**Application by National Highways for the Lower Thames Crossing
DPWLG Response to the Examining Authority's Written Questions and Requests for Information (ExQ1)**

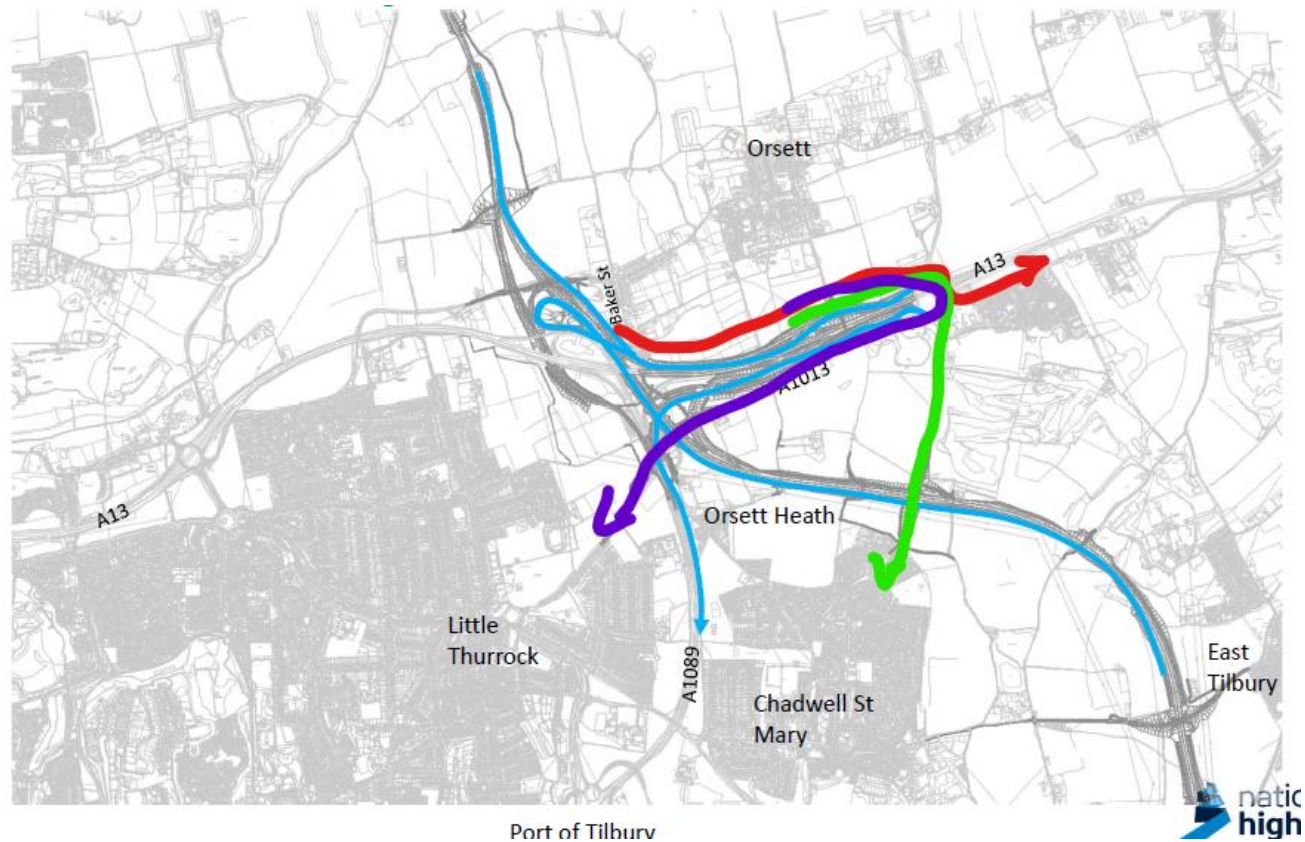
There is clearly a heavy reliance on Orsett Cock to accommodate these movements. In addition to this are in fact three key additional movements at the junction as highlighted below.

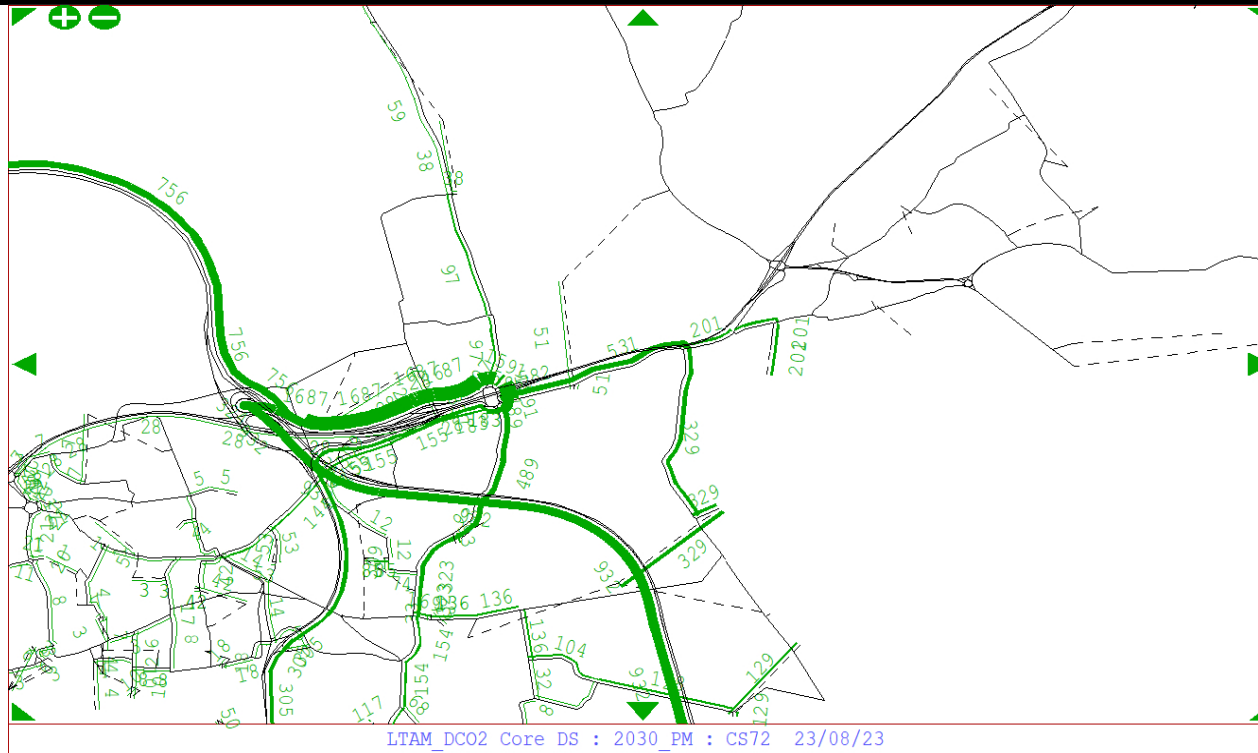
Table 1 of REP3-154 shows change in traffic inputs (as extracted from the NH Vissim model) with and without the LTC. There are significant changes to flows from LTC to the A13 and A1013 Westbound, but also to the south (Brentwood Road) and east A1013 towards Stanford Le Hope. These are significant and material changes in flows on all arms of the junction. This issue has been further clarified by data provided by the applicant in respect of the LTAM model, an extract of which is provided below which is the extract of movements to Orsett Cock from LTC in 2030 PM Peak.

The data shows three key issues:

- 1) The level of traffic approaching / using Orsett Cock from the LTC is in the order of **1,700** PCUs
- 2) The level of U-turning traffic (i.e A13 EB – A13 W/B) is lower than DTA had previously assumed and is around 309 PCUS.
- 3) However, in addition to this there is a significant flow from LTC to both Brentwood Road (489 PCUs), A1013 Eastbound (towards Stanford Le Hope (582 PCUS) and A1013 Westbound (183 PCUs).

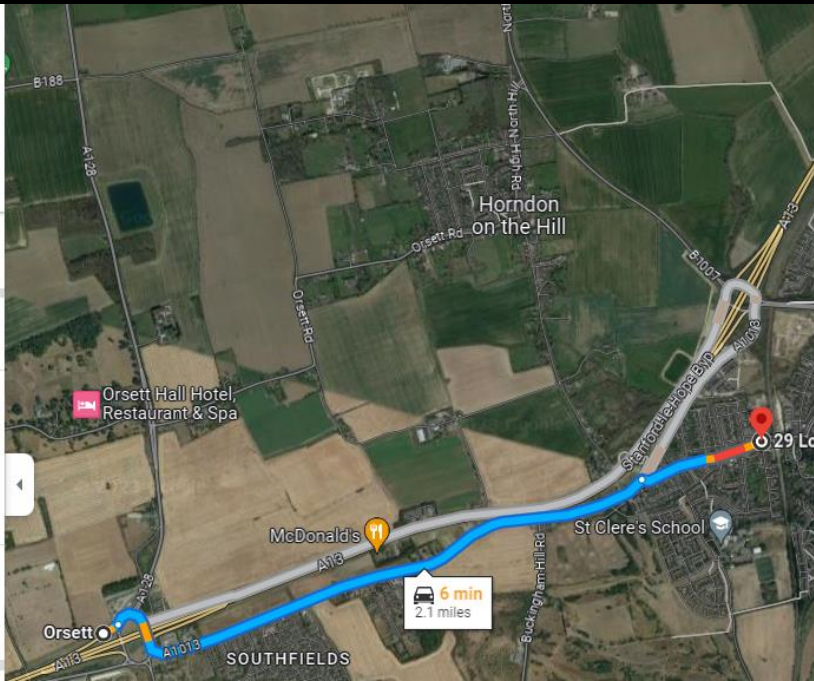
ExQ1	Question to:	Question:
		<p>REP2-154 confirms the concern that congestion at Orsett Cock is likely to lead to a version or reassignment to Orsett Cock as follows:</p> <ol style="list-style-type: none"> 1) Significant queuing on the A128 southbound approach will mean traffic using this as route from the A127 to join the A13 is likely to use the B1007 and Manorway Interchange in preference. This was a concern raised in REP1-333. 2) Those travelling from the LTC to Tilbury, Little Thurrock or Chadwell St Mary, will see the existence of a lengthy queue on the approach to Orsett Cock (the junction itself will not be visible from the tail of the queue) and chose then to avoid the queue and instead U-turn at Manorway Interchange. The assessment at 2.2.34 of REP1-333 clearly shows the journey time via Manorway Interchange is clearly comparable with the applicants own Vissim assessment of movement through Orsett Cock. 3) Of further concern, now that the above information has been provided is those significant number of vehicles (nearly 600 PCUs) who are using Orsett Cock to reach Stanford Le Hope. For those movements, clearly the use of Manorway Interchange is likely to be equal in terms of journey time even without delays at Orsett Cock and there is a high chance those will route via Manorway Interchange for the same reasons as described above. A comparative assessment from google below highlights this:

This new information, therefore, highlights (and heightens) the concerns raised about the potential impact of the scheme at Manorway Interchange.
